TLE9868QXB20 - BF-Step

Overview

This document lists the errata of the TLE9868QXB20

Figure 1 Measurement unit - overview for TLE9868QXB20 (DS: Figure 25)

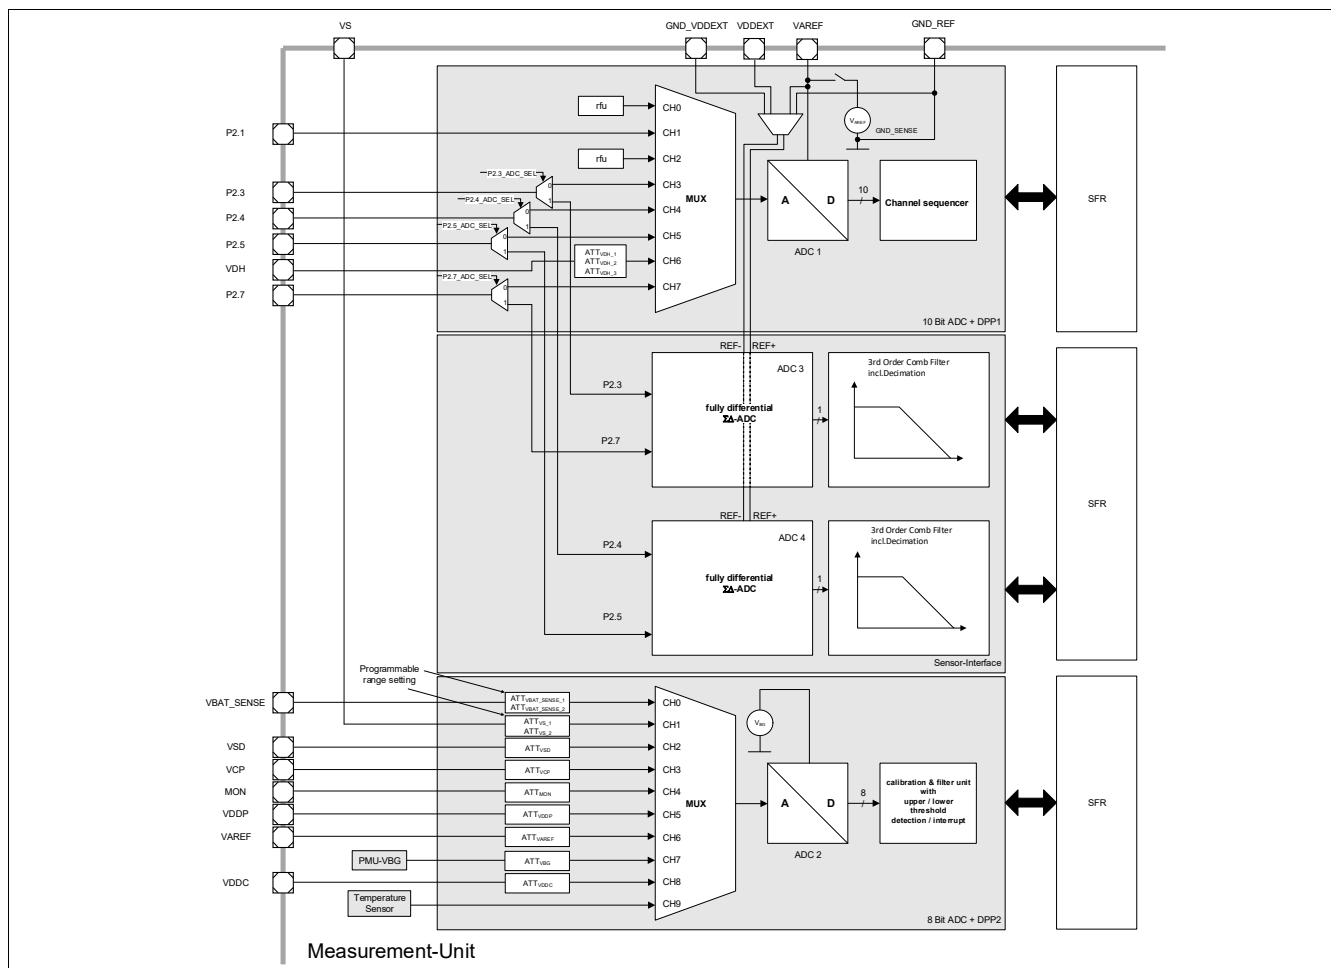
The **Figure 1** displays an update for the corresponding figure in the data sheet (Figure 25). The attenuator values have been replaced by the corresponding symbols described in the electrical characteristics chapter in the data sheet. The reference voltage for the ADC1 (5V) has been replaced by the symbol V_{AREF} which is specified in the electrical characteristics chapter. The reference voltage for the ADC2 (1.23V) has been replaced by the symbol V_{BG} which is specified in the electrical characteristics chapter.

Fix with next user documentation update.

Figure 2 External XTAL circuitry (UM: Figure 21)

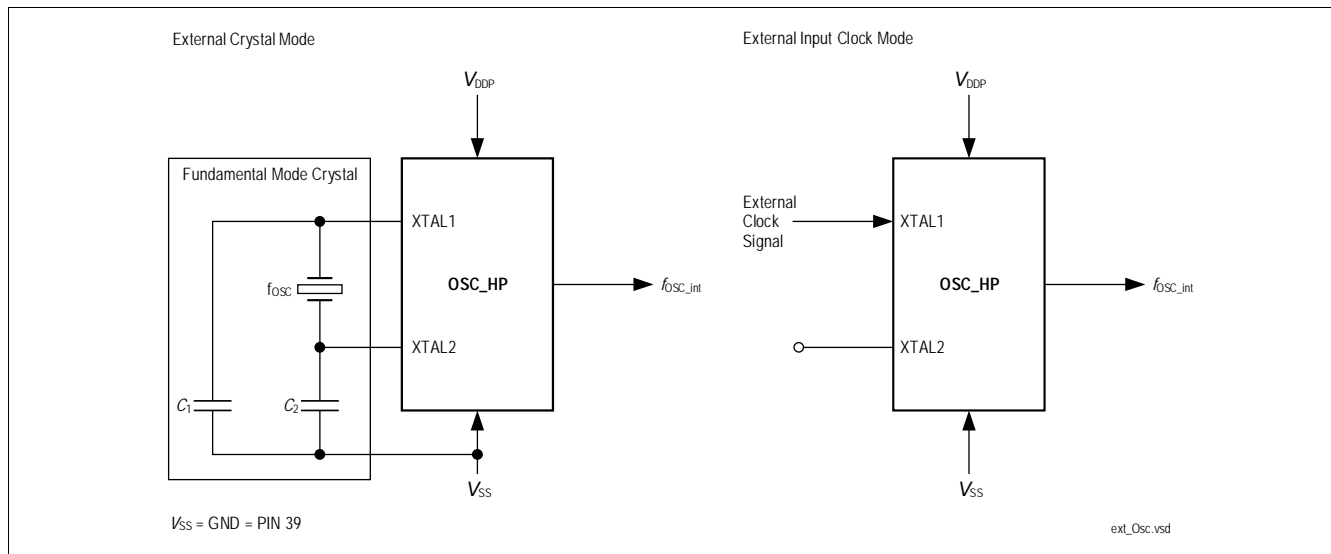
The **Figure 2** has been updated, the frequency values, 4 - 25 MHz, for the external crystal have been replaced by the specification symbol, f_{OSC} .

Fix with next user documentation update.

Figure 3 LIN internal circuitry (UM: Figure 174)

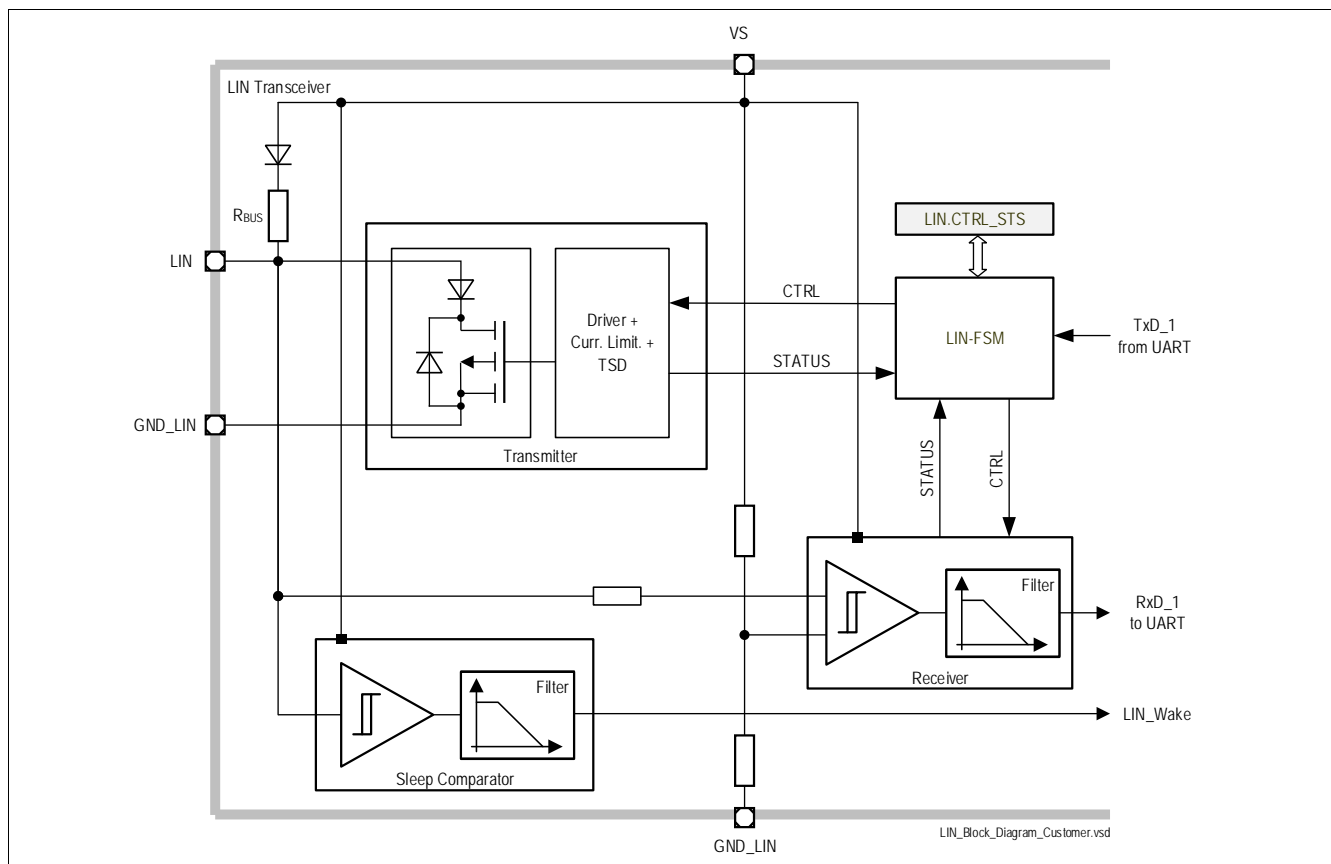
The **Figure 3** has been updated, the value for the device internal pullup, 30 kOhm, has been replaced by the specification symbol, R_{BUS} .

Fix with next user documentation update.

Figure 6 Register view of specified SHPR2 register

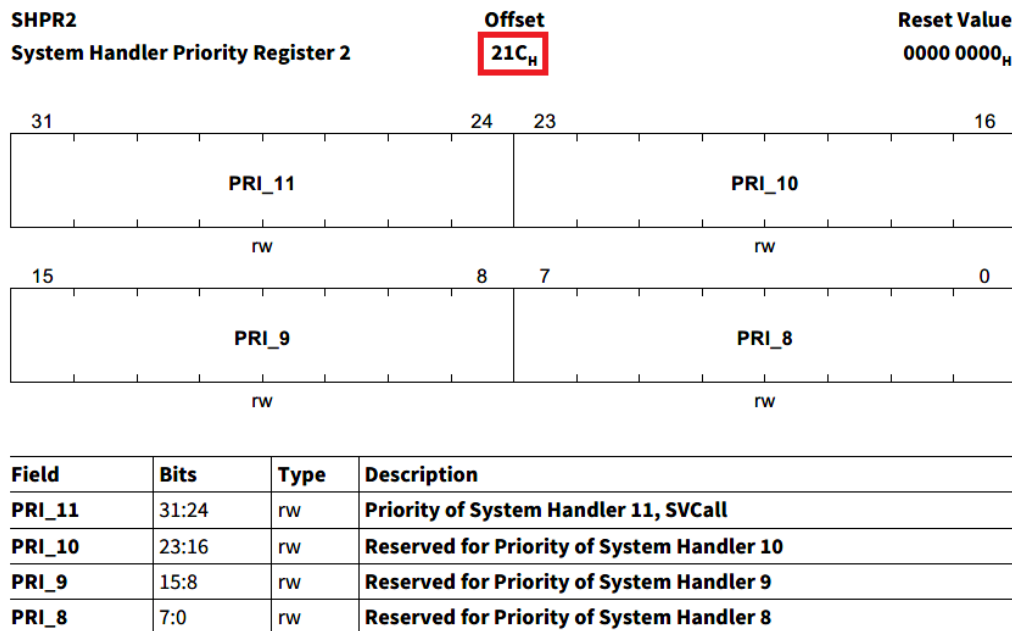
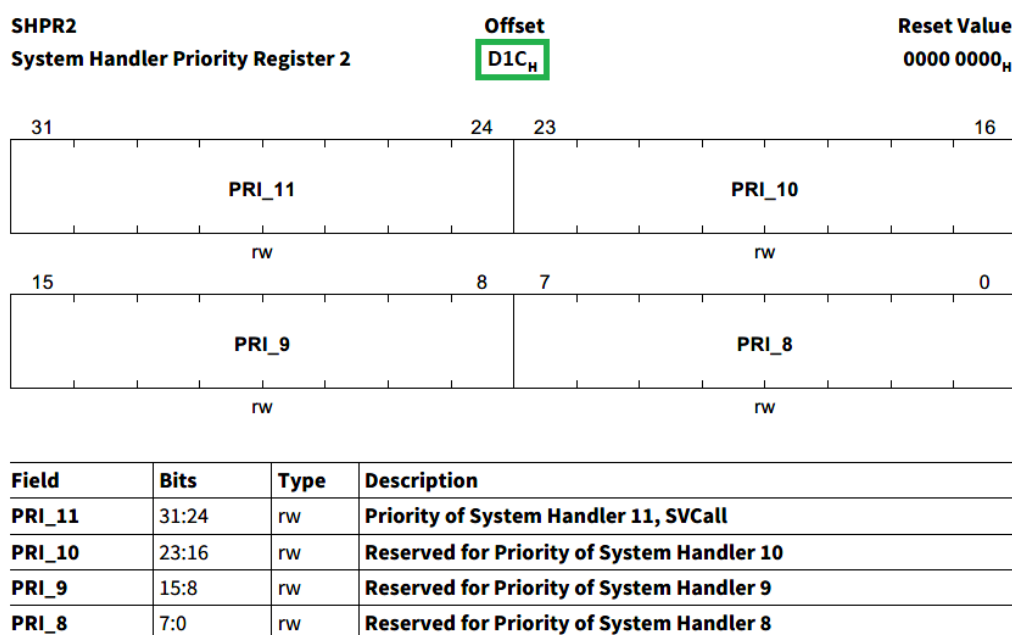
The address of the register SHPR2 is specified wrongly.

The implemented address for the register SHPR2 is 0xE000ED1C.

Fix with next user documentation update.
